Docket No. 50-346
License No. NPF-3
Serial No. 994
October 11, 1983

APPLICATION FOR AMENDMENT
TO
FACILITY OPERATING LICENSE NO. NPF-3
FOR
DAVIS-BESSE NUCLEAR POWER STATION
UNIT NO. 1

- I. Changes to Davis-Besse Nuclear Power Station Unit 1, Appendix A, Technical Specifications Sections 4.1.2.1, 4.1.2.2., 3.1.2.8 and 3.1.2.9.
 - A. Time required to Implement. This change is to be effective upon NRC approval.
 - B. Reason for Change (Facility Change Request 82-111 Rev. C)

FIGURE-2

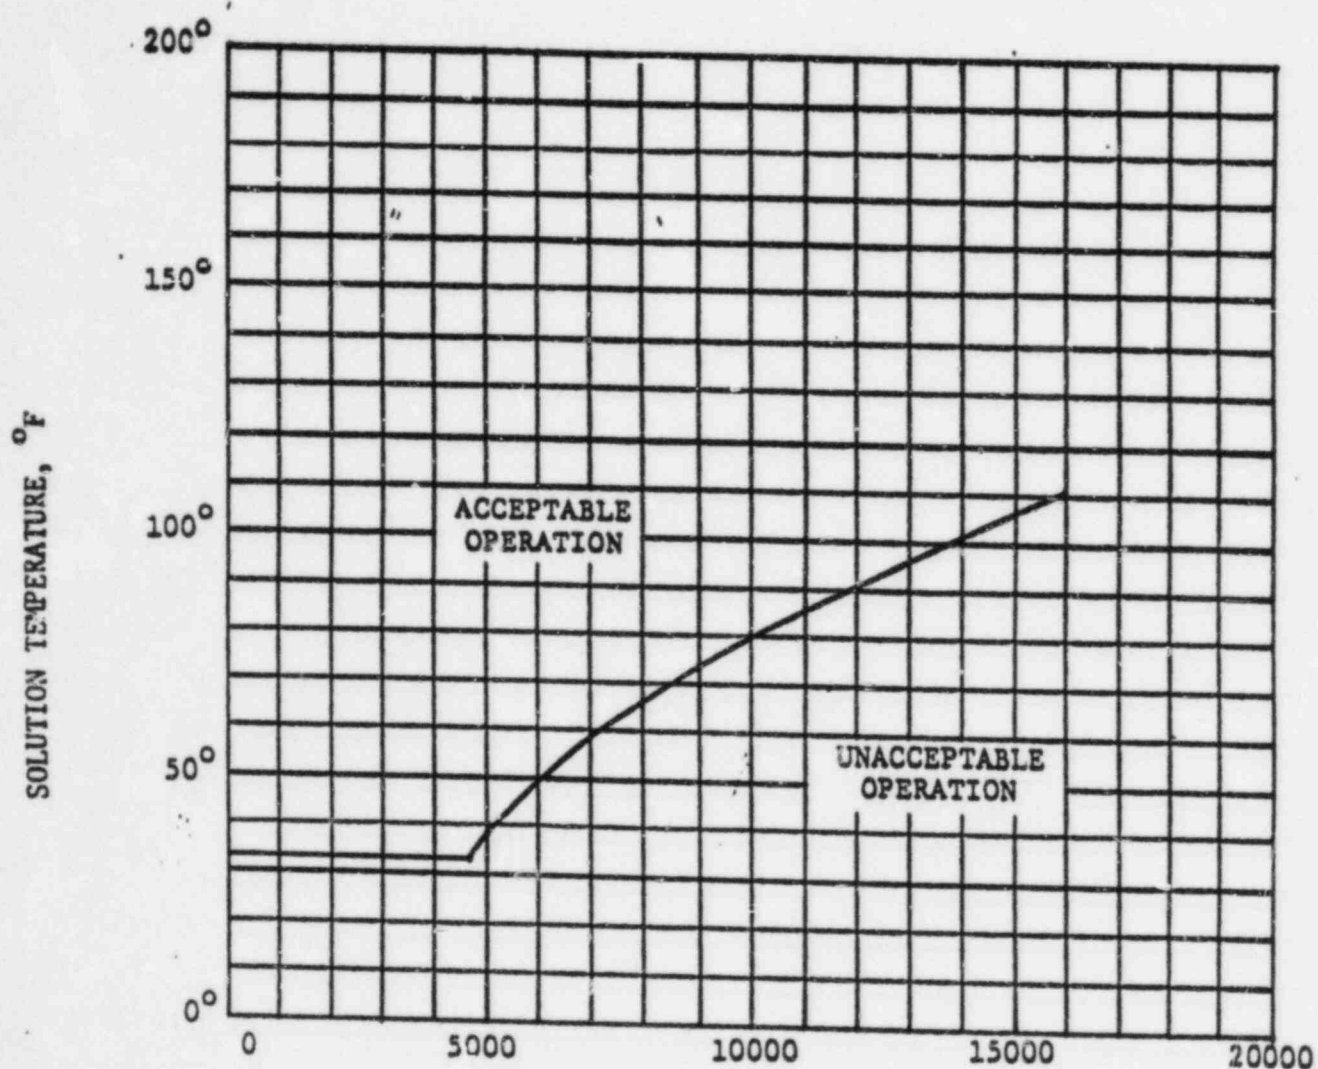
The only time the need for temperature verification exists is during and after the flow path has been used for transporting boric acid with a source concentration of >5000 ppmB. If at any time the line is used for transporting the boric acid of source concentration <5000 ppmB, the temperature need not be maintained above 105°F, since per the attached Figure 2 the crystallization will occur only below the freezing point of approximately 32°F. Thus, there is no safety concern for boric acid crystallization under those circumstances. Liquid samples are taken from the source for verification of boron concentration (not from the flow path) and this is so reflected in the revised Technical Specifications.

The proposed modification to the Technical Specifications allows for conditions when the verification of surveillance requirements is to be completed close to a time when the flow path has been or is being used to transport low boron concentration solutions. Thus, if the seven day verification of temperature falls during transfers of low boron concentration solutions, the verification period may be extended up to 8 hours after the addition of dilute boron solution has been stopped for at least 8 additional hours. This implies that the seven day temperature verification is not required if the line is being used for transport of low boron concentration water either continuously, or, intermittently as long as the time period between two successive (low boron concentration) water transports is less than 8 hours. This period is considered adequate and
